To: Richmond City Council
From: Councillor Harold Steves
Chair, Planning Committee
Re: **APPLICATION BY H.A. BERG INVESTMENTS LTD. FOR REZONING AT 11991 NO. 1 ROAD AND 3931 CHATHAM STREET FROM SERVICE STATION DISTRICT (G2) TO STEVESTON COMMERCIAL (THREE-STOREY) DISTRICT (C5)**

Re: **Application by H.A. Berg Investments Ltd. for Rezoning at 11991 No. 1 Road and 3931 Chatham Street from Service Station District (G2) to Steveston Commercial (Three-Storey) District (C5)**

To Council - Nov 27 2006
 To Planning - Nov 21, 2006
 Date: November 2, 2006
 RZ 05-296591
 File: 12-8000-20-8115.

To: Mayor and Councillors
From: Jean Lamontagne
Director of Development
Date: December 12, 2006
File: RZ 05-296591
Re: **Application by H. A. Berg Investments Ltd. for Rezoning at 11991 No. 1 Road and 3931 Chatham Street from Service Station District (G2) to Steveston Commercial (Three-Storey) District (C5)**

WEST ELEVATION

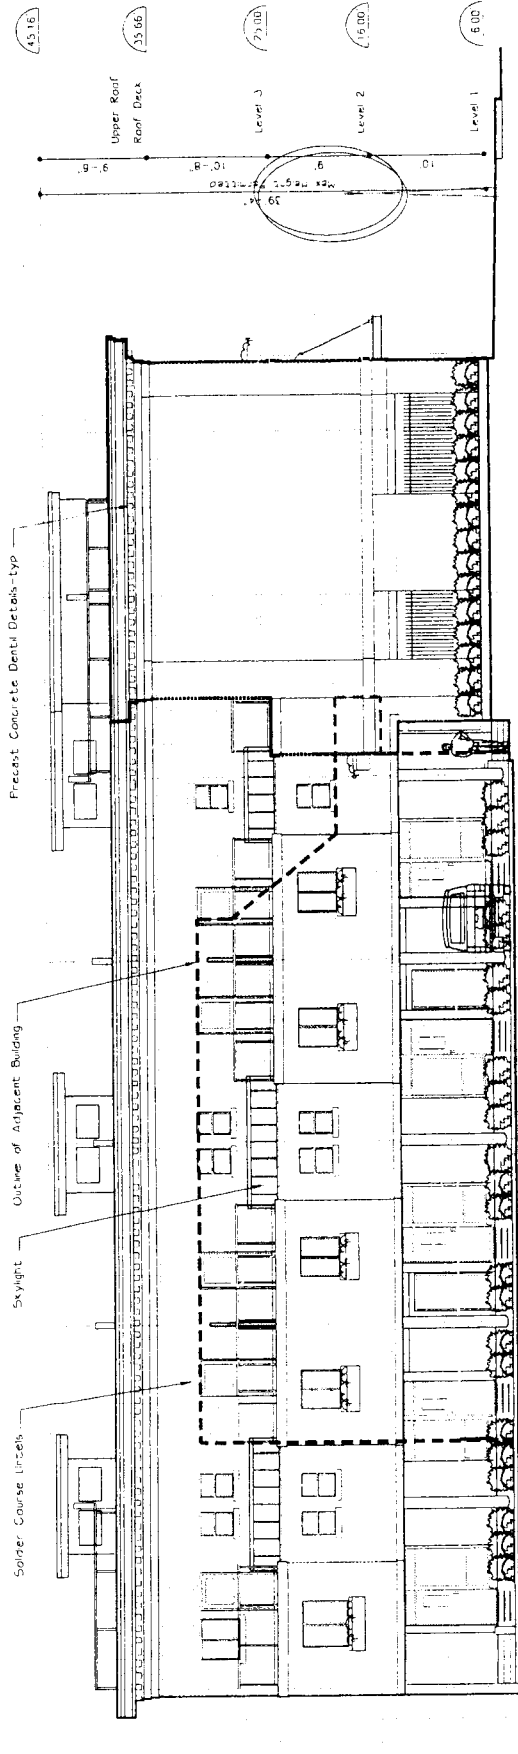
- The current design has incorporated windows on the west elevation. The building is built close to the property line, there might be limiting distance issues with respect to the amount of proposed openings.

SOUTH (CHATHAM ST) ELEVATION

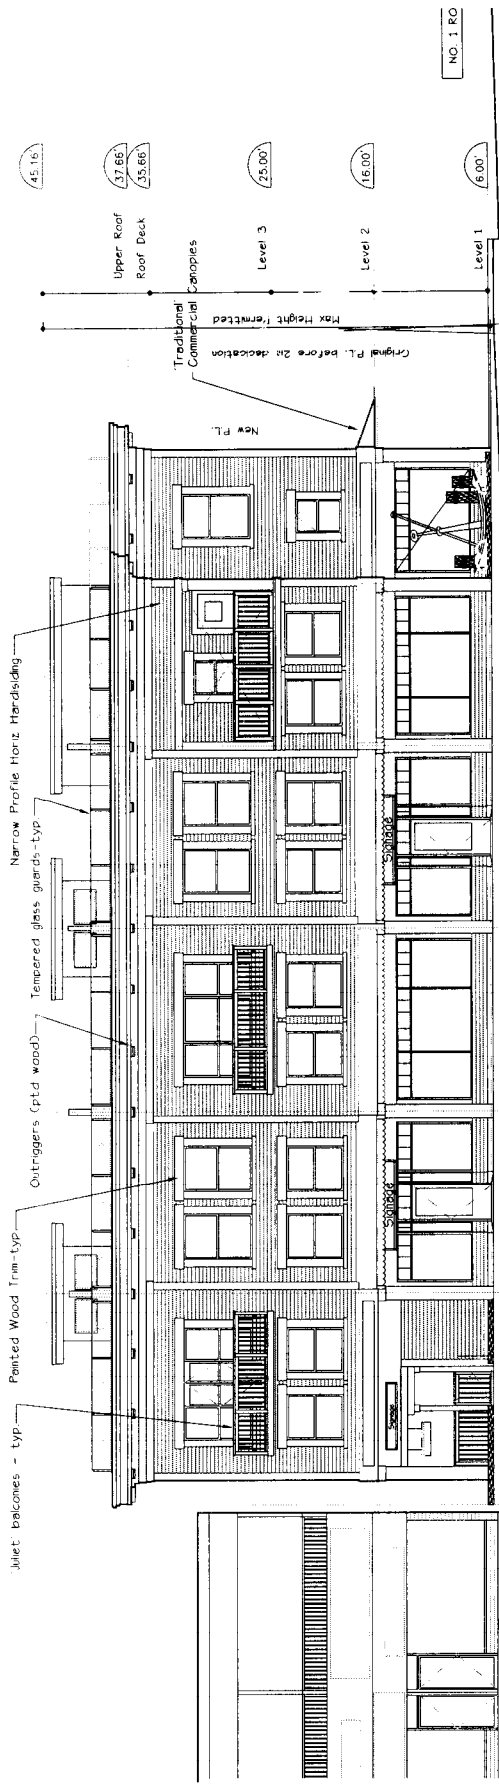
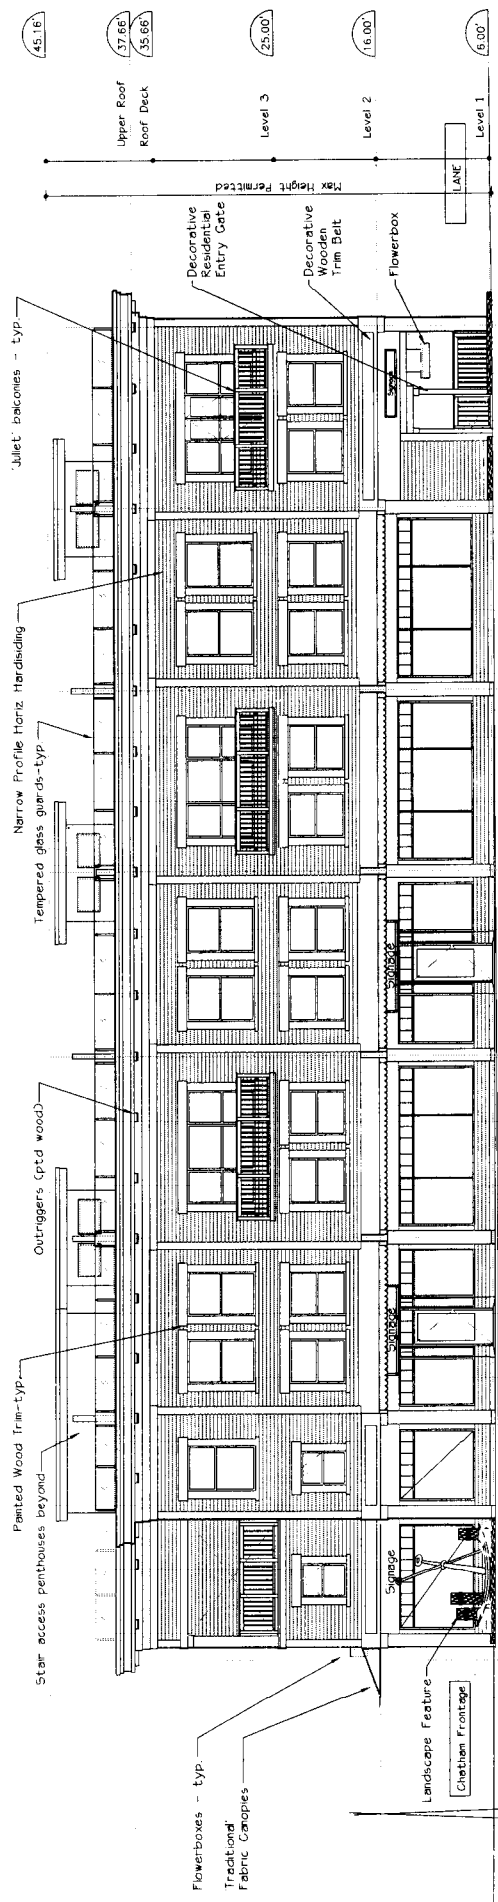
Modified drawings are attached to this memo, along with the architect's rationale for the revised design. The applicant has addressed the concerns of Council by changing the building cladding, awning design and incorporating gardening opportunities on the roof deck.

The brick cladding has been changed to narrow profile horizontal Hardi-plank siding to emulate heritage bevelled wood siding. Glass and steel canopies have been replaced with fabric-covered awnings with a heritage scalloped hanging edge.

The building will be clad predominantly with narrow profile hardboard/wood siding with 8" to 10" wide painted wood trim around windows and doors and at building corners. A prominent wooden soffit cornice with wooden outriggers (reminiscent of the the Hepworth Building) is proposed at the parapet roof edge. 'Heritage' colours are proposed and the proponent is eager to work with Planning to determine 'authentic' historic Steveston colours if possible. Balcony railings are of wood picket design. Decorative 'Juliet' balconies are proposed to recall the historic 'Steveston' look of the past. Simple fabric sloping canopies with scalloped skirt edges and artisan-type fascia store signage complete the 'traditional' look.
